The fuseholder OGN has new ratings and approvals as follow:

Product Change Notification						OGN new approval			
owner	creation date	release date	released by	change order no	rev	page	D10 007 255		
dislercy	2016-08-11	2017-01-31	nowakfr	2011797	A	1 of 2	D10-007-255

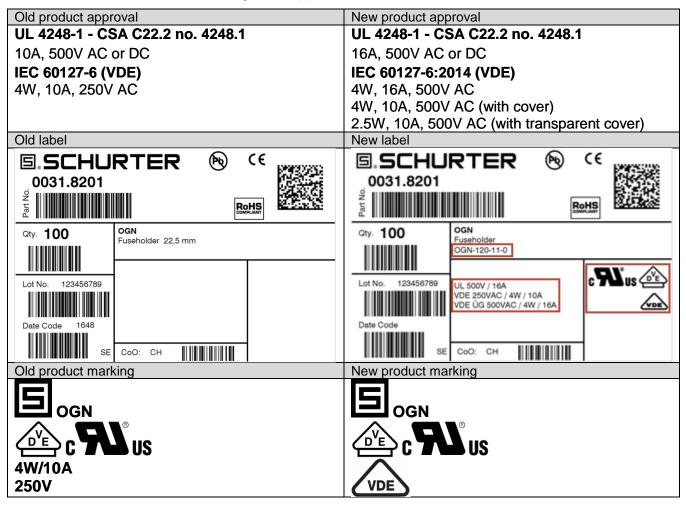
- Modified label
- Improved electrical ratings
- Change of markings

Form	Yes	Inscription on socket changed
Fit	No	No change for dimension
Function	Yes	Rating enhancement acc. IEC and UL/CSA
Manufacturing	No	No change for manufacturing site
Label	Yes	Approvals and configuration code on label
Packaging	No	No change in packaging
